APPLICATION NUMBER: 10.2023.59.1

PROPERTY DESCRIPTION: LOT: 2 DP: 805229, Dido Street KIAMA

DEVELOPMENT DESCRIPTION: Demolition of existing development and subdivision of land for the creation of 67 residential lots and 1 community lot. Housing comprising 60 semi-detached dwellings and 7 detached dwellings are proposed to be constructed on the residential lots. The Community lot will include a private road network, public recreational park, stormwater and civil infrastructure and rehabilitation of the existing riparian corridor. The development will also include site establishment such as earthworks, vegetation removal and services.

DATE: 31 January 2024

Figure 3 – Subdivision Plan (C2 Environmental Conservation Zone hatched grey)

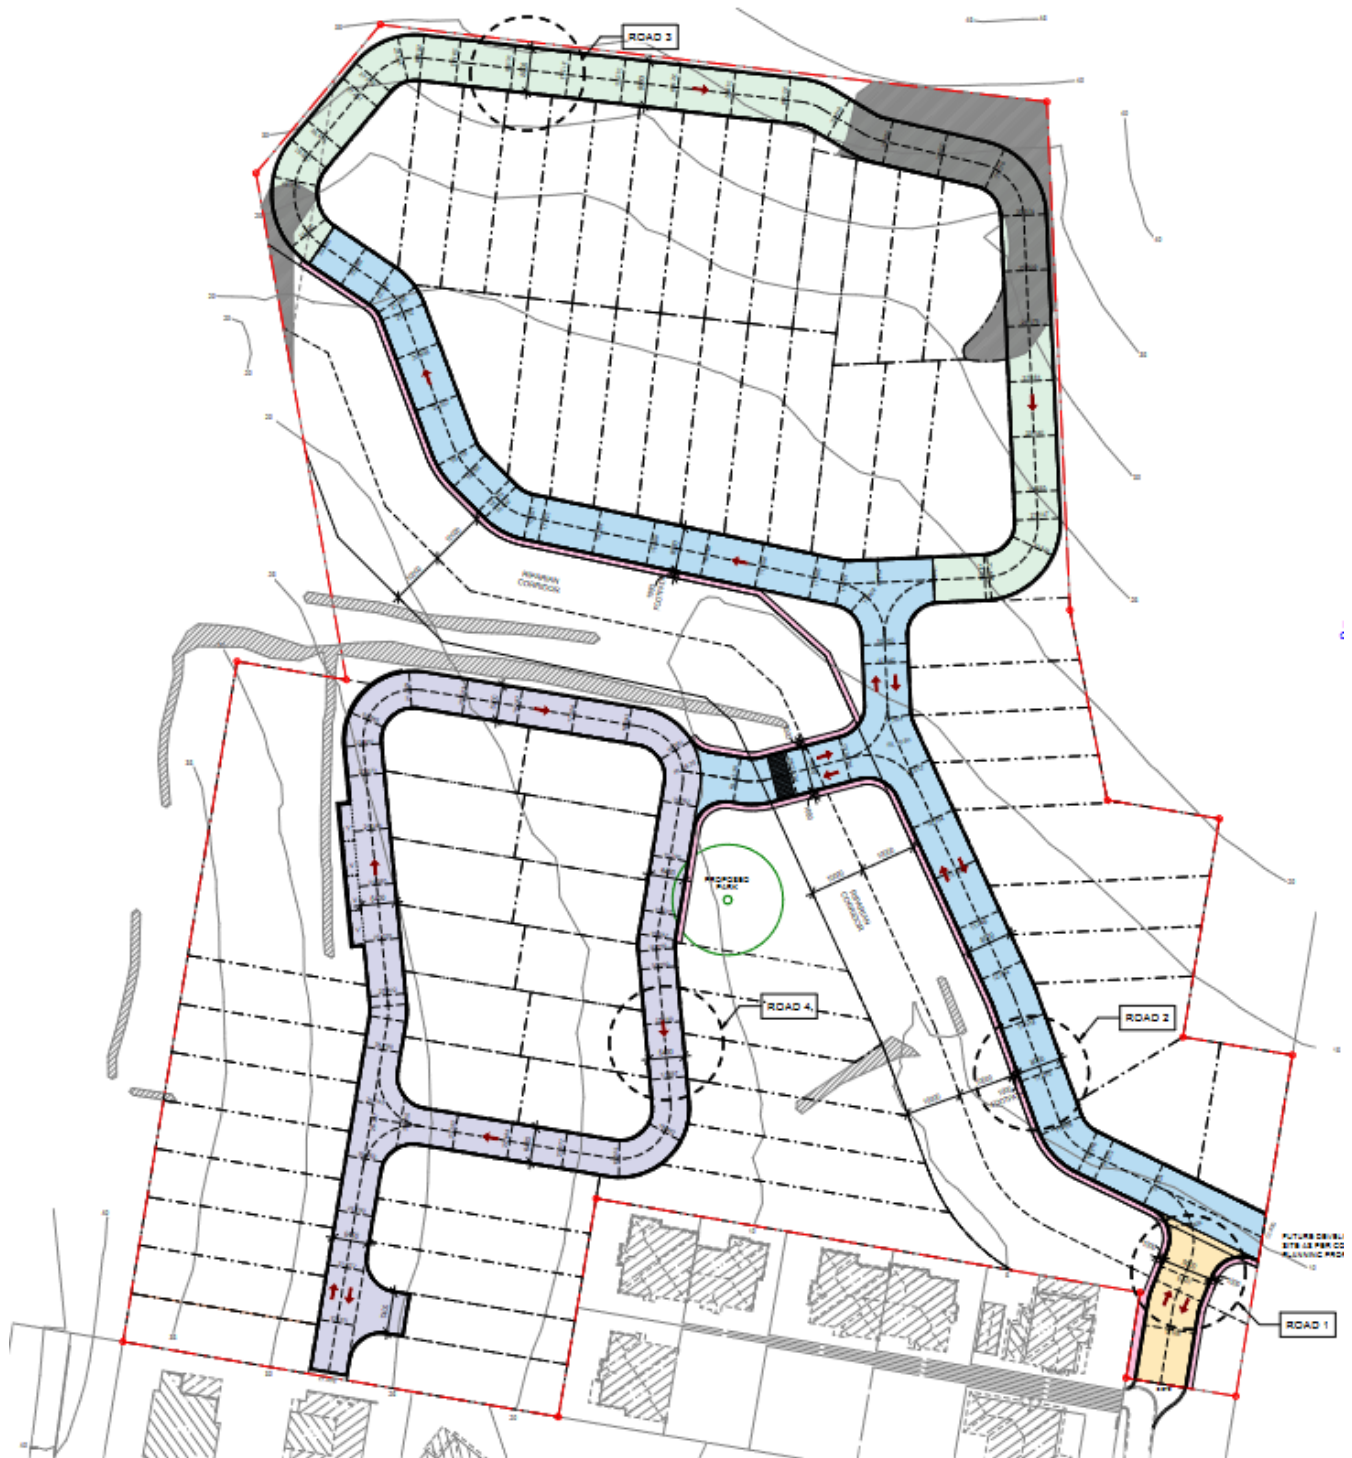
Comment – The proposal is considered an acceptable form of low density residential development with a mix of detached and semi detached dwellings. The subdivision design is supported by the Flora and Fauna Assessment which finds that minor portions of the site zoned C2 at the north-eastern corner and along the western boundary are not significantly impacted noting presence of exotic woody species and lantana in these areas.

Notwithstanding, this is not grounds alone for support of the proposal at the present time, noting the lack of flood free egress as discussed later in this report.

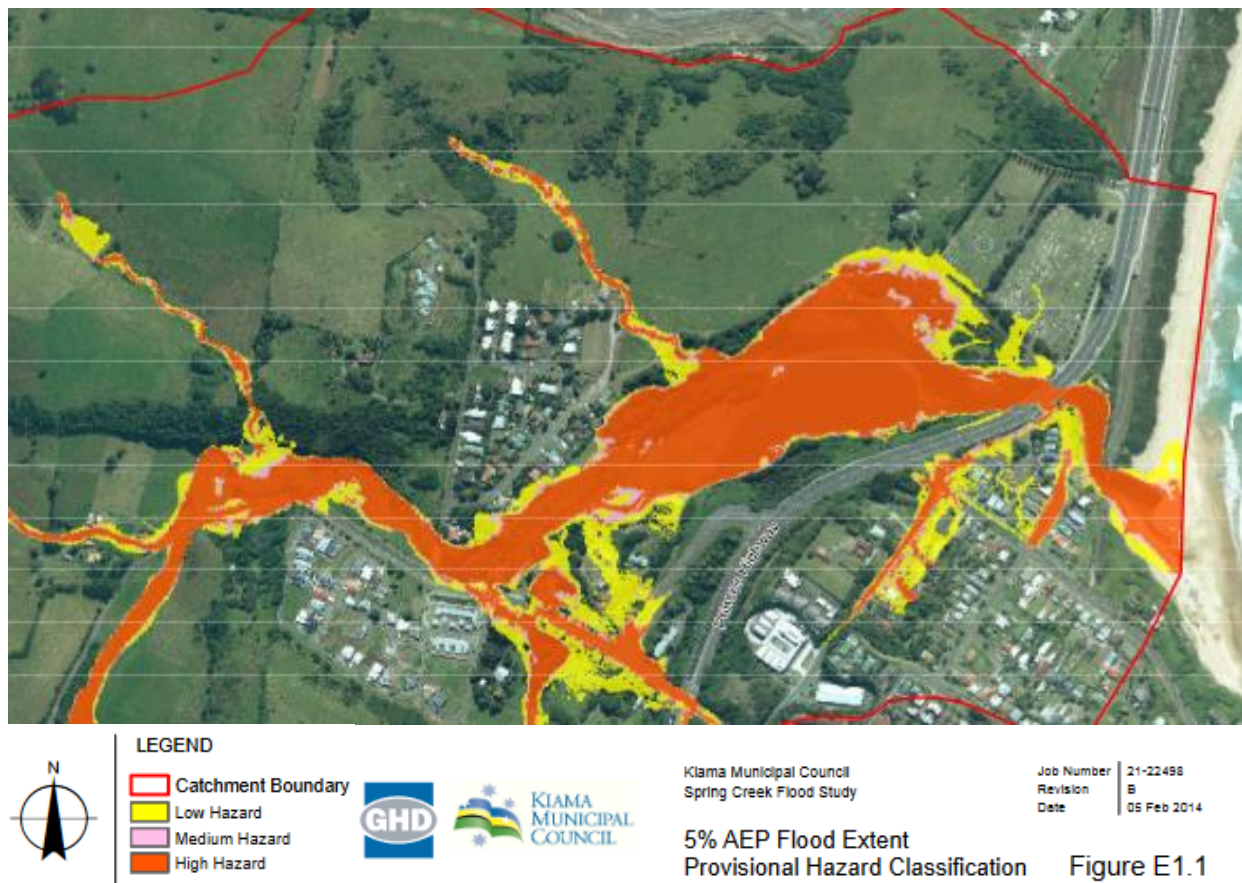
The Dido Street bridge is within an area mapped as 'high hazard' as shown in the 5% AEP Flood Extent at Figure E 1.1 of the Study. Based on this Council's engineering comments included in this report state with regards to the 5% AEP:

Safe carriageway for waterway crossings is required in low flood conditions (5% AEP). Due to the significant increase in development density compared to the existing, and number of residents accessing the road, and those potentially needing help from the SES during emergency events, the existing Dido Street access bridge is considered insufficient.
